UNITED STATES PATENT AND TRADEMARK OFFICE

10/656,797

Office Action Summary	Application No. 10/656,797	Applicant(s) STARKSEN, NIEL F.	
	Examiner KATHERINE M. DOWE	Art Unit 3734

DETAILED ACTION

Applicant's annotated drawings presented on pages 11-12 of Remarks filed May 11, 2009

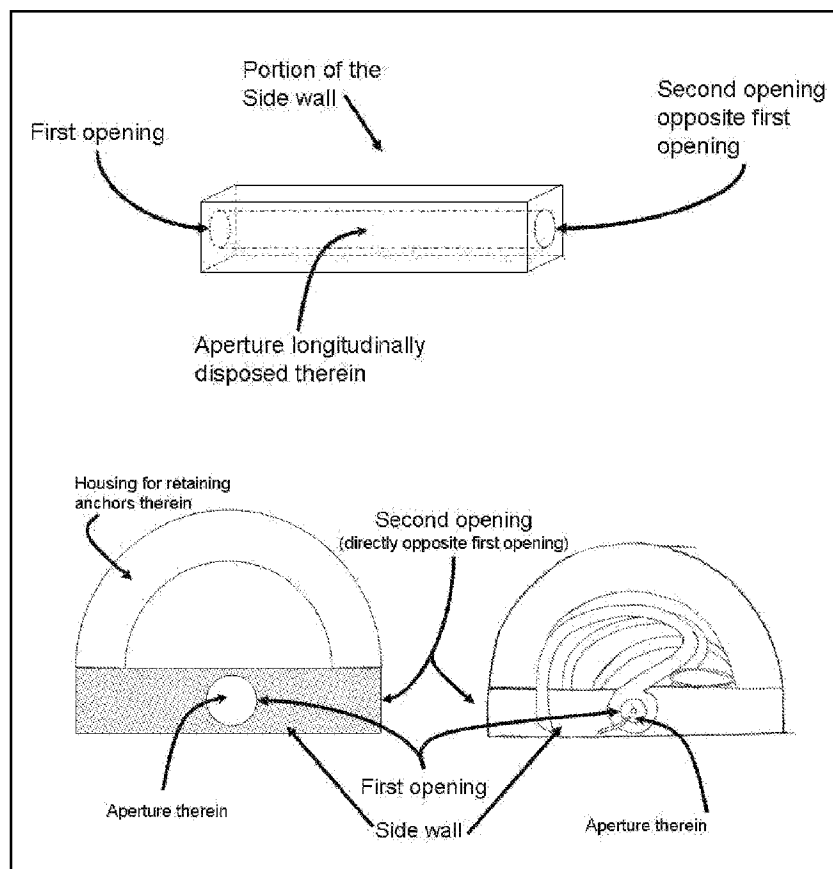
In the remarks filed May 11, 2009, Applicant argues the limitation, "wherein the side wall has at least one aperture disposed longitudinally therein the aperture having a first opening and a second opening" should be interpreted such that the "aperture" is equivalent to a lumen within the side wall of the housing, separate from the main lumen of the housing. And the "first and second openings" should be interpreted as proximal and distal openings of the lumen. See Applicant's sketch/annotated drawings provided in the remarks filed May 11, 2009 copied below:

The specification does not recite any type of aperture within the side wall of the device, separate from the main lumen of the housing. Furthermore, the drawings do not clearly depict such an aperture. The specification additionally does not recite any structural relationship between the mandrel and the housing, other than that the mandrel couples the hooks, or anchors, to the device. The drawings appear to show the mandrel is within the main lumen of the housing device, not within a separate lumen within the side wall of the housing. The Examiner additionally notes neither the specification nor the drawings depict or describe the proximal end of the device, and thus there is no support for a second opening opposite the first opening, whether or not the Applicant is referring to the lumen within the side wall of the device or if the Applicant is referring to the main lumen of the housing that contains the anchors and the tether.

Examiner's annotated version of Figure 8 of instant application

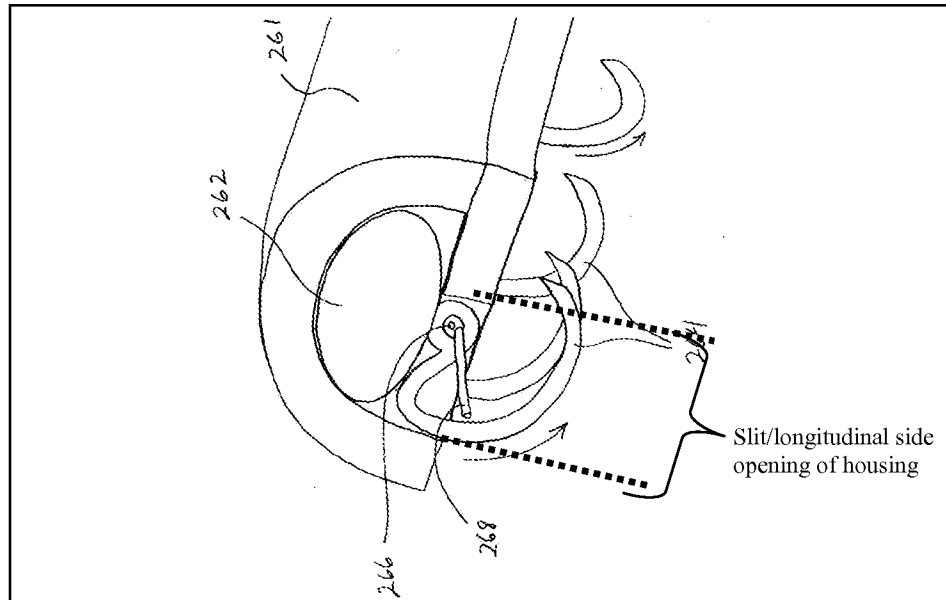
As shown above, Applicant argues the "aperture" should be interpreted as a lumen within the side wall of the housing, separate from the main lumen of the housing. It is unclear how the device will operate as disclosed if the mandrel may be housed within its own aperture within the sidewall of the housing. The ends of the hooks that should be coupled to the mandrel are not capable of encircling the mandrel if the mandrel is within its own aperture separate from the main lumen of the housing. The only way the hooks may be coupled to the mandrel as disclosed is if the hooks and mandrel are contained within the same aperture. However, if the hooks are contained within the lumen of the side wall, the hooks are not capable of pivoting about the mandrel to engage tissue. Figures 5A-5D and 8 clearly show the anchors, tether, and mandrel are housed within a main lumen of the housing, wherein the housing comprises a slit or side opening for the anchors to be pivoted out through and engage tissue. See annotated portion Figure 8 below:

No such aperture appears to be disclosed. The specification does not recite the term "aperture" or "opening", much less a "first opening" and a "second opening". The drawings do not clearly show the claimed aperture or openings either. Furthermore, if

the mandrel is contained within an aperture, or lumen, of the side wall separate from the main lumen of the housing, it is unclear how the anchors may be coupled to the mandrel and how the anchors may pivot about the mandrel to engage tissue.

8. The drawings are objected to under 37 CFR 1.83(a). The drawings must show every feature of the invention specified in the claims. Therefore, the aperture disposed longitudinally within the side wall of the housing having first and second openings and a mandrel retained therein must be shown or the feature(s) canceled from the claim(s). No new matter should be entered.
